South Texas Project Electric Generating Station P.O. Box 289 Wadsworth, Texas 77483

December 11, 2008  
NOC-AE-08002372  
10CFR50.54(f)

South Texas Project  
Units 1 and 2  
Docket Nos. STN 50-498 and STN 50-499  
Supplement 4 to the Response to Generic Letter 2004-02  
(TAC Nos. MC4719 and MC4720)

**Supplement 4 to the Response to Generic Letter 2004-02**

Figure 7 – ECCS Schematic

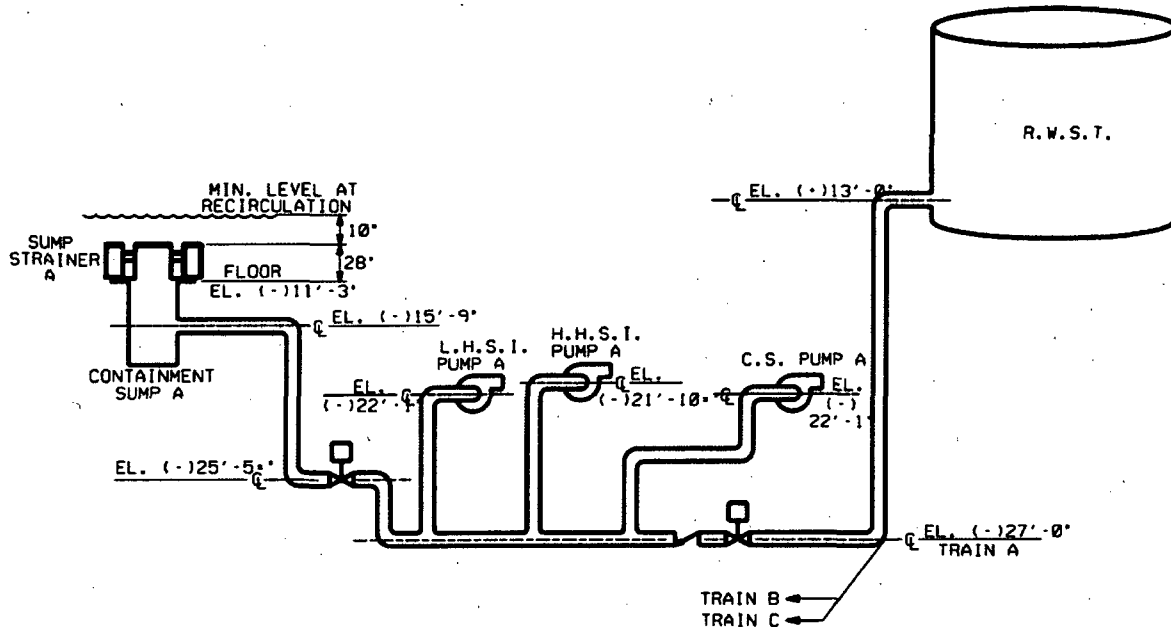
- Provide a schematic diagram of the emergency core cooling system (ECCS) and containment spray systems (CSS).

See Figure 7 below for schematic with elevation layout.
